MEMORANDUM

TO: Montgomery County Planning Board

SUBJECT: MD 28 at MD 97 Intersection Improvement Study Recommendations

Recommendation: Transmit the following comments to the State Highway Administration

MD 28 & MD 97 Intersection Improvement Study Environmental Assessment	
Project Study Area	Date: October, 2002
	Figure: 1-2

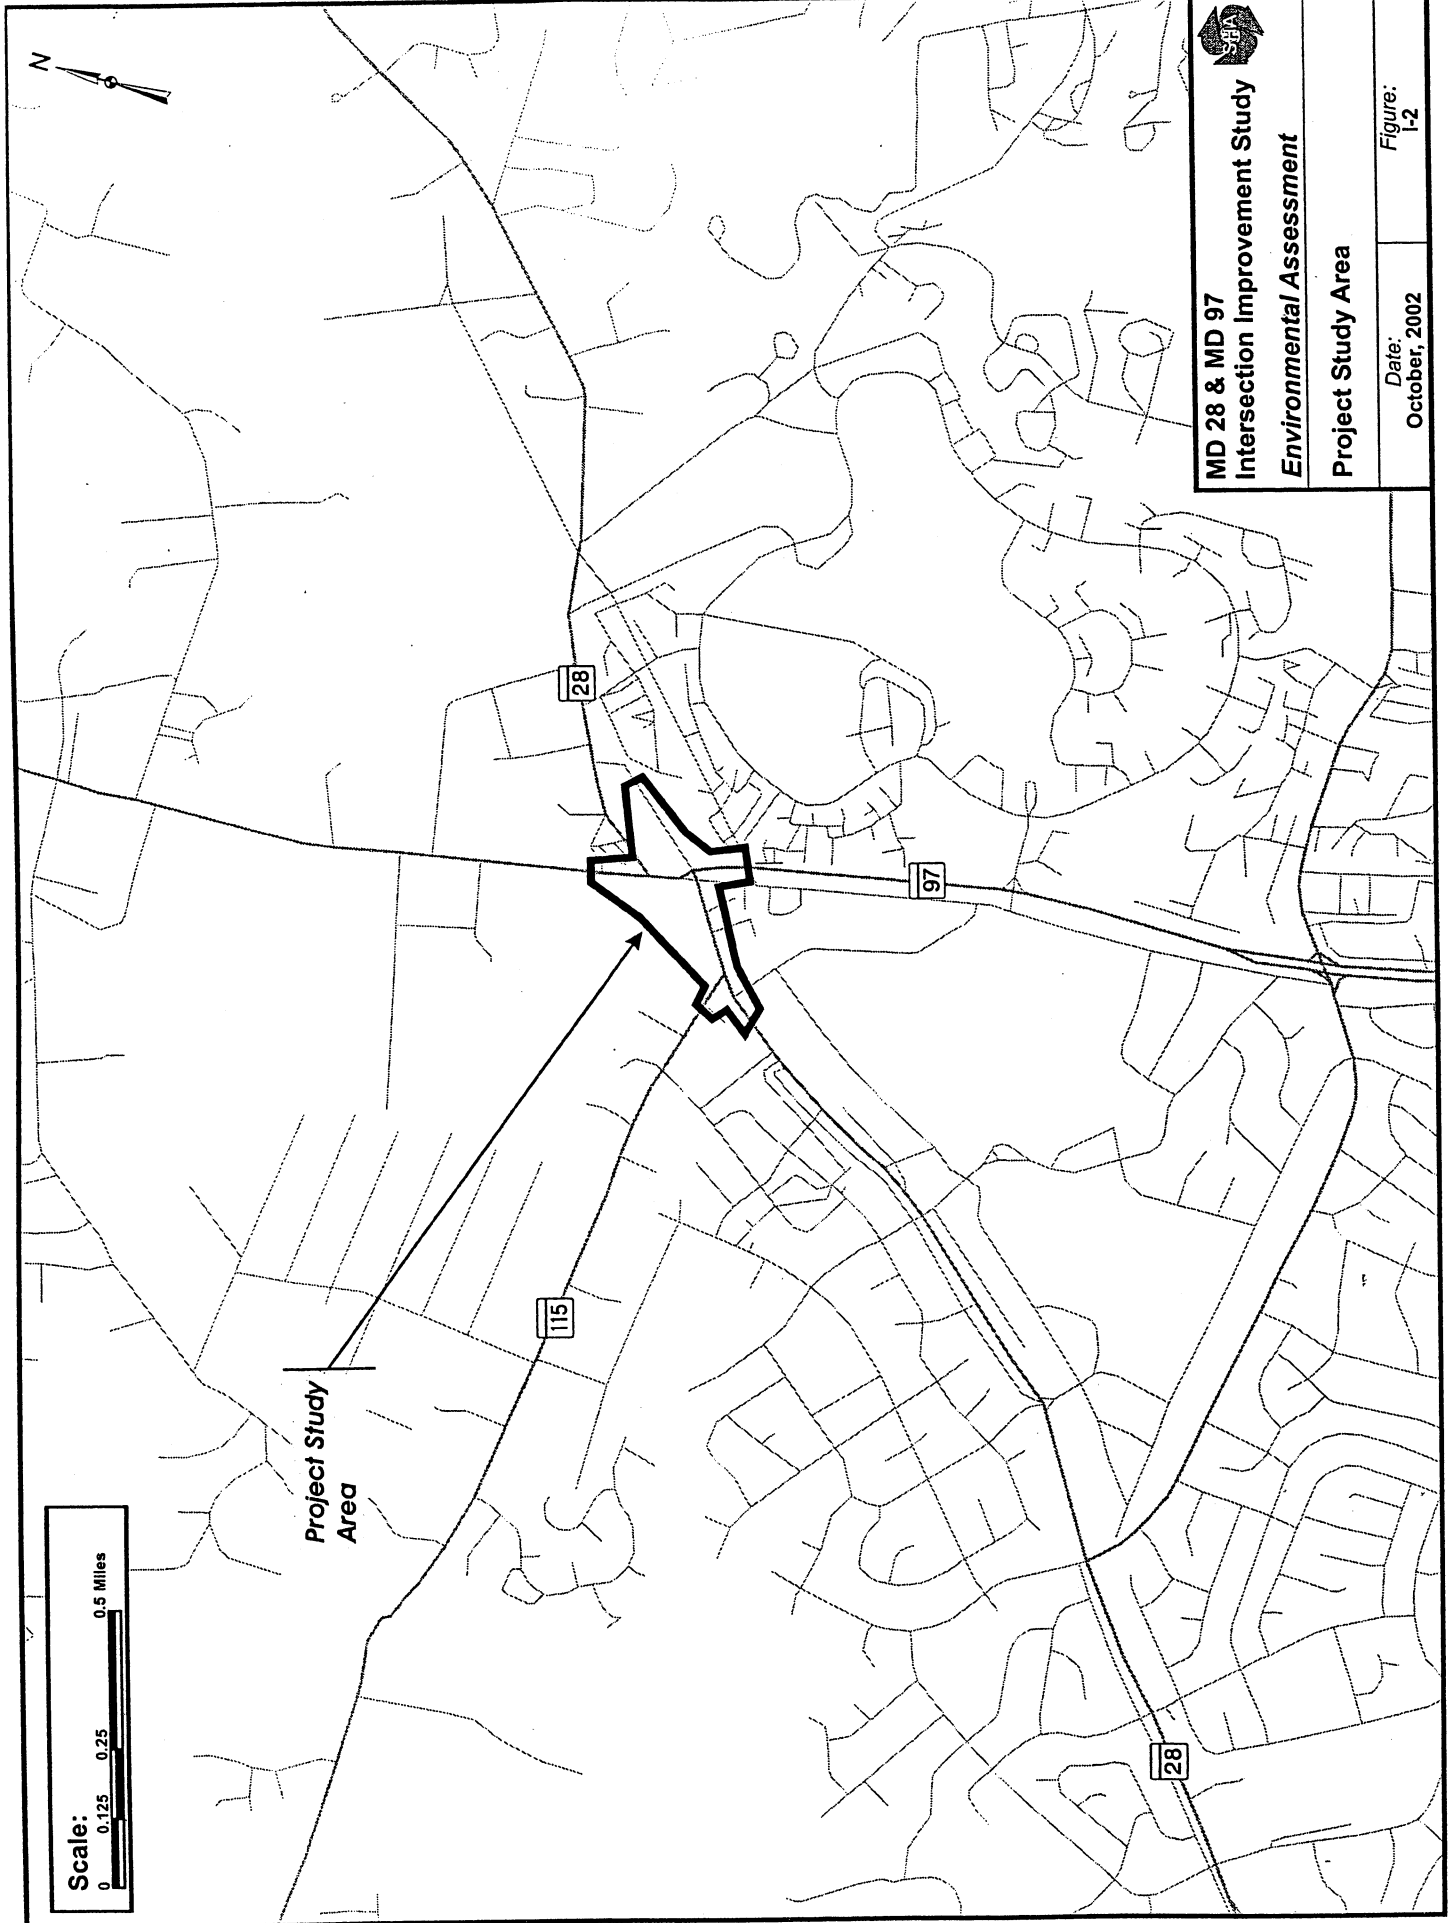
The purpose of this briefing is to provide comments to State Highway Administration in the selection of a preferred alternative for the MD 28 at MD 97 Intersection Improvement Study. The study location is shown in Exhibit 1.
